REMARKS

Appl. No. 10/801,180
Amendment dated March 9, 2005
Reply to Office Action dated September 9, 2004

ANNOTATED SHEET SHOWING CHANGES

Figure 1

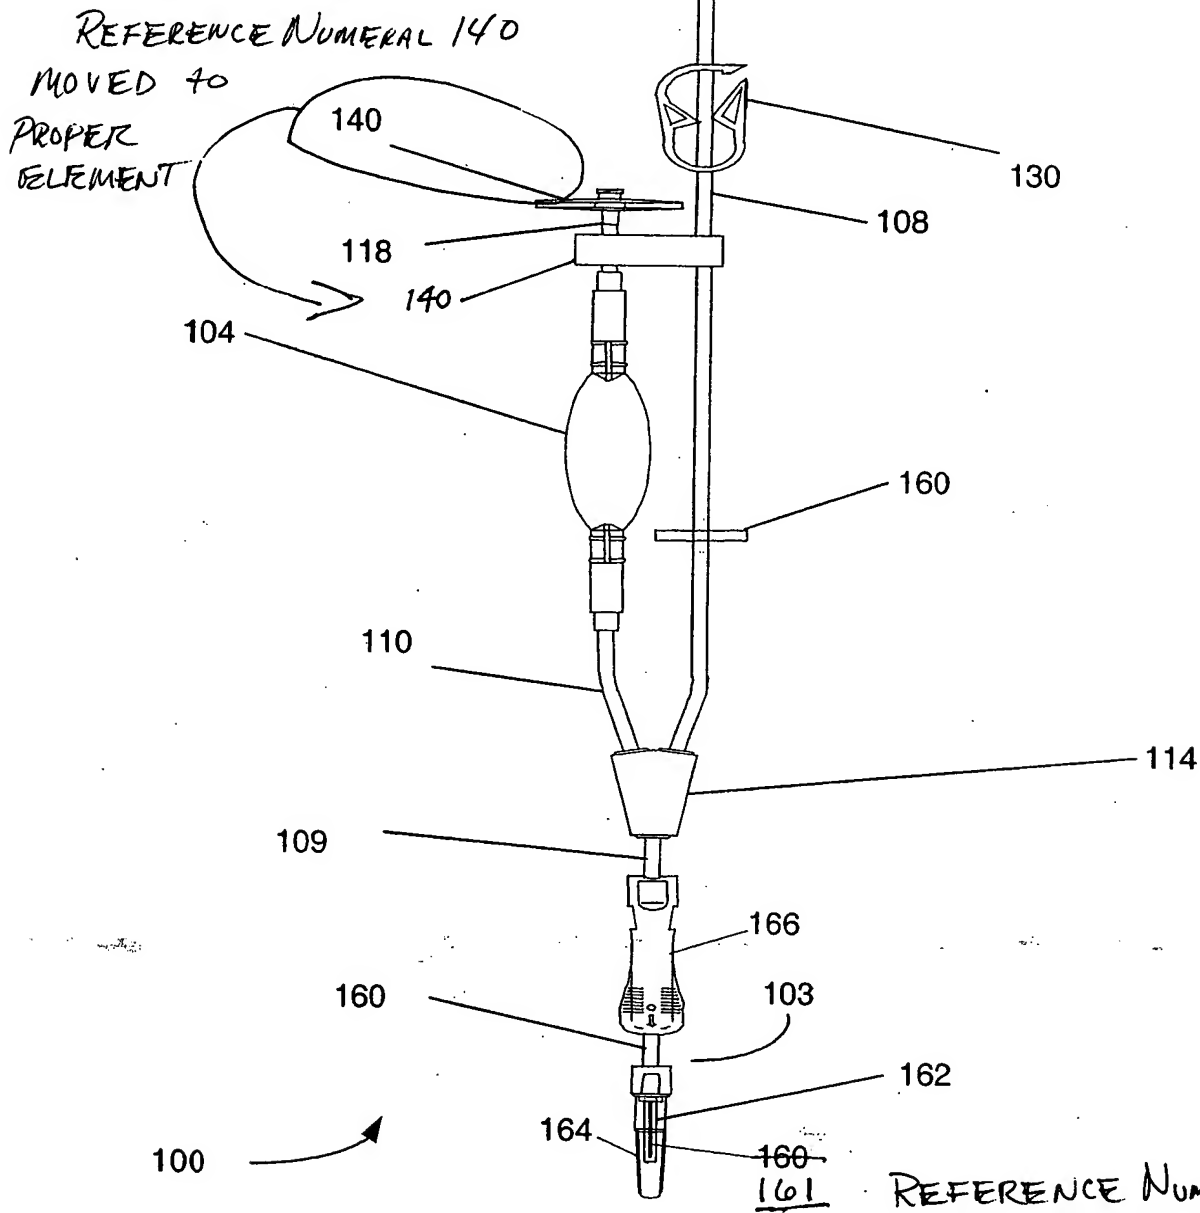
The attached sheets of drawings include changes to FIGS. 1 and 4. The attached sheets replace the original sheets showing FIGS 1 and 4. In both FIGS. 1 and 4, the same two changes are made: 1) reference numeral 140 erroneously pointing to the vent in the original drawings, has been moved to properly indicate the clamp located upstream to the vent; 2) the second appearance of reference numeral 160 (indicating the spike) has been changed to 161 to avoid confusion with the one-way valve, also originally numbered with 160.

At various places on page 10, reference numeral 160 used to identify the spike, was changed to reference numeral 161. This change corrects a clerical error by which reference numeral 160 was accidentally used to identify two different elements (the one-way valve and the spike). The one-way valve remains as reference numeral 160 and the spike has been renumbered as 161. Corresponding changes were made in the drawing as outlined above.

Figure 4

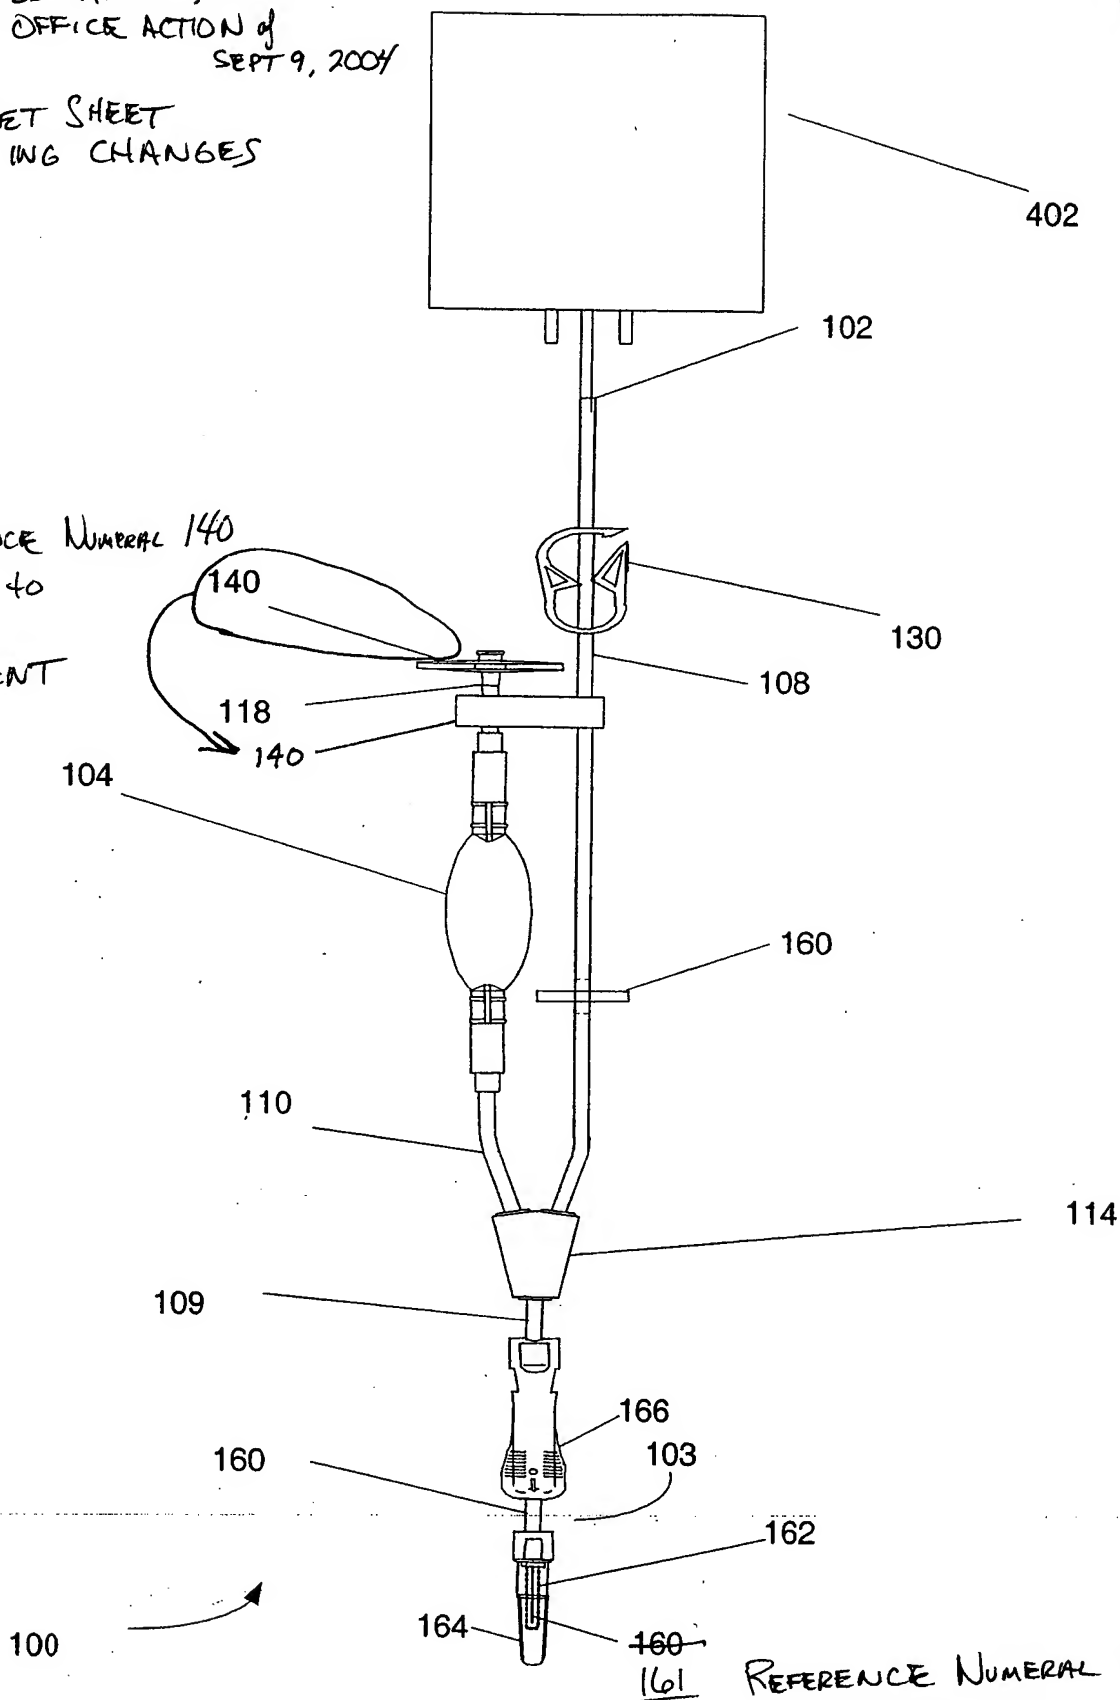
REFERENCE NUMERAL 160
 CHANGED TO 161
 TO CORRECT DOUBLE
 NUMBERING
